## Sunbeam Service Sheet No. 11

**Subject: Timing Chain Tensioner fitted to Engines with S.8 Prefix**

**Date: July 1951**

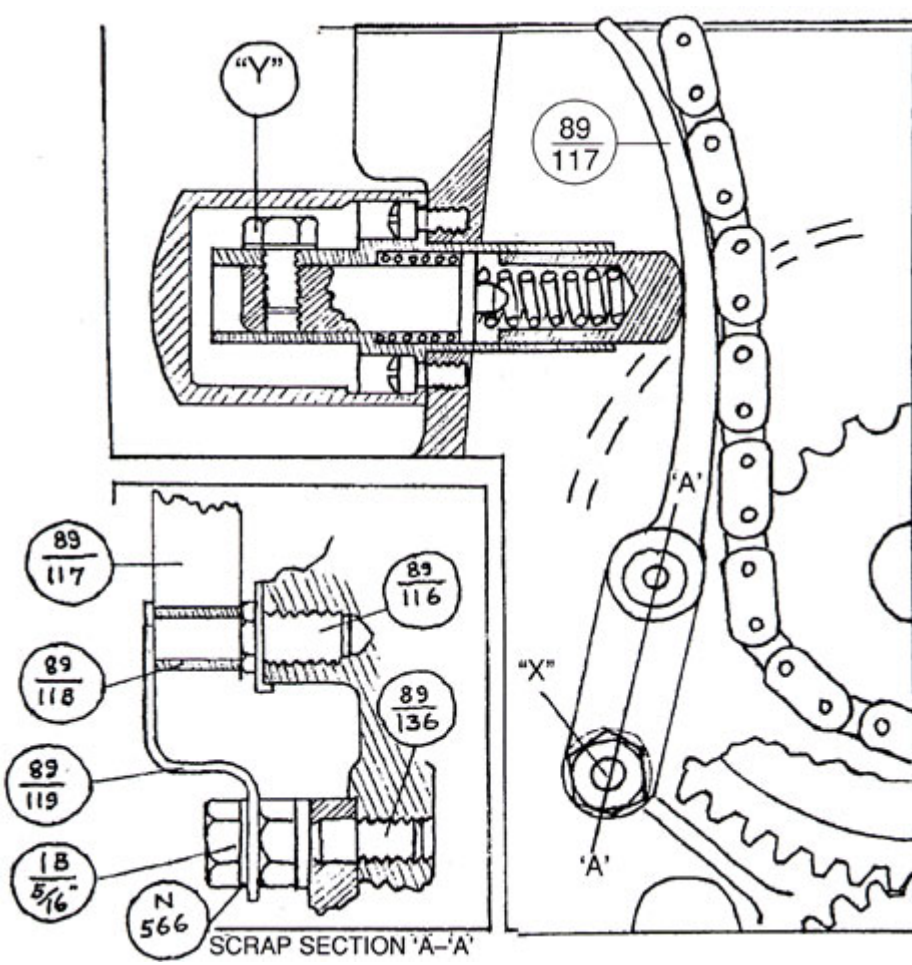
To overcome premature failure of the tensioner and spring, the complete assembly has been redesigned. The modified components can be fitted to all engines bearing the S.8 prefix.

Remove the nut and spring washer from the end cover stud immediately below the pivot pin (*marked "X" in drawing overleaf*) and extract the stud. Replace with the new stud 89-136 and replace the original nut and spring washer.

Slacken off the  $\frac{1}{4}$ " bolt (*marked "Y" in drawing overleaf*) and screw the assembly into the crankcase using the fibre washer originally removed from the inspection plug.

Bend back the lock washer and remove the existing tensioner blade pivot pin and replace with the new washer and pin No. 89-116. Ensure that the lock washer is bent over the stud hexagon and the flat on the crankcase.

Feed the new chain tensioner blade 89-117 on to the pivot pin and insert the bush 89-118.

The retaining clip 89-119 can now be fitted over the end cover stud and pivot pin and secured by nut 1B -  $\frac{5}{16}$ " and spring washer N 566.

Turn the engine until either of the exhaust valves is partly open then tighten bolt "Y" securely.
